PERMIT

SEWAGE DISPOSAL SYSTEM

SUBDIVISION Spring Hollow

LOT 11

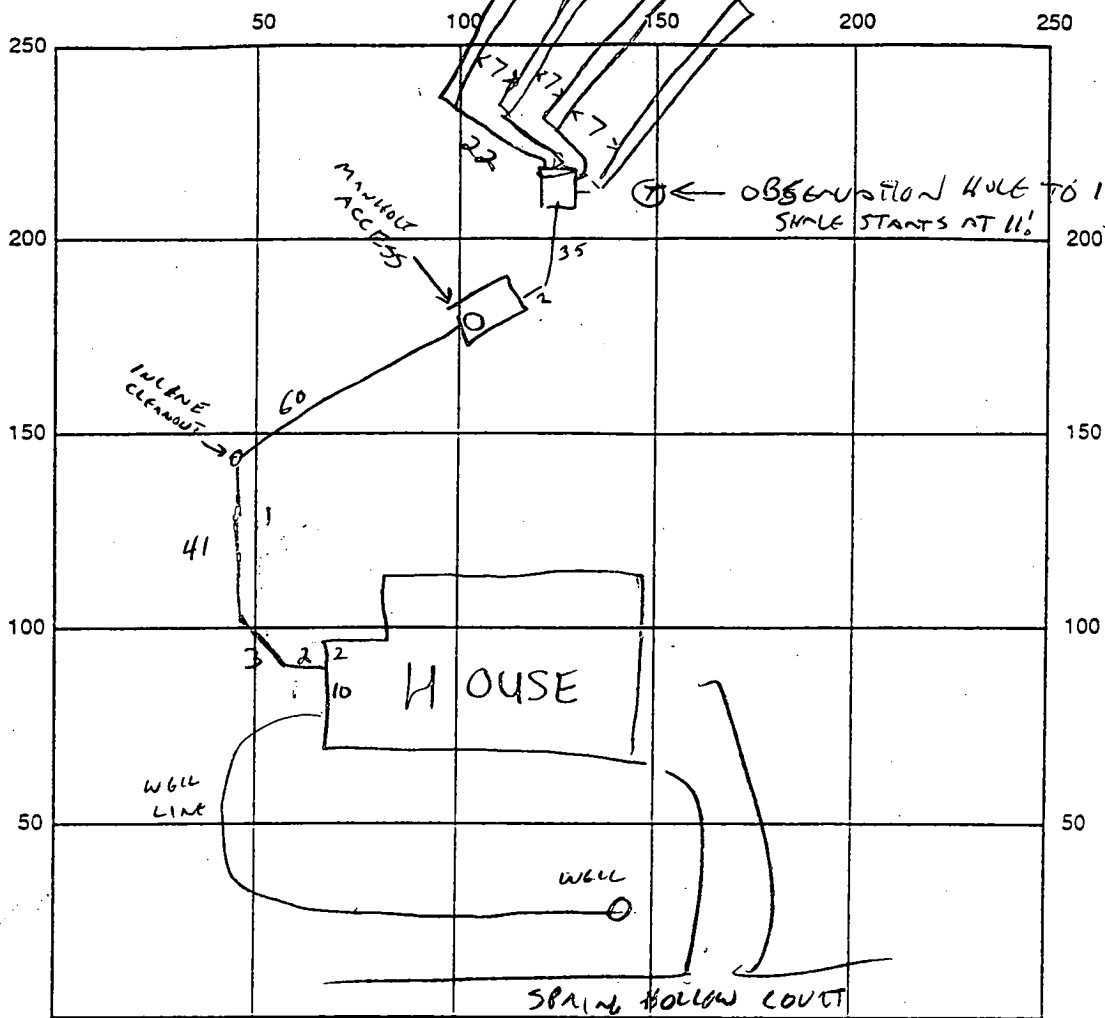
CONTRACTOR REPORTS HOUSE PLUMBING
SET DEEPER THAN PLANNED, AND
CLAY LAYER IN UPPER TRENCH IS ALSO
DEEPER THAN EXPECTED, 2' BUCKET BEING USED.
SEE BELOW FOR REVISED SPECIFICATIONS. CW

REMARKS: SYSTEM COMPLETED DEEPER THAN ORIGINALLY SPECIFIED,
OBSERVATION HOLE CONFIRMS ADEQUATE TREATMENT AREA REMAINS. OK TO COVER. 2/17/00

REVISED SPECS: 2' WIDE, 4 1/2" INLET, 6' BOTTOM, 2' STONE. CW 2/17/00
WITH ADDITIONAL LENGTH TO COMPENSATE FOR VOLUME/SURFACE AREA.

DRAIN FIELD/TITLE DEPTH 6 1/2 - 7 FT. TRENCH WIDTH 2 FT. INLET DEPTH 4 - 4 1/2 FT.

EFFECTIVE GRAVEL DEPTH 2 1/2 FT. TOTAL LENGTH 300 FT.

NUMBER OF TRENCHES 4 @ 75 ONE SIDEWALL/BOTTOM AREA 750 SQ. FT.
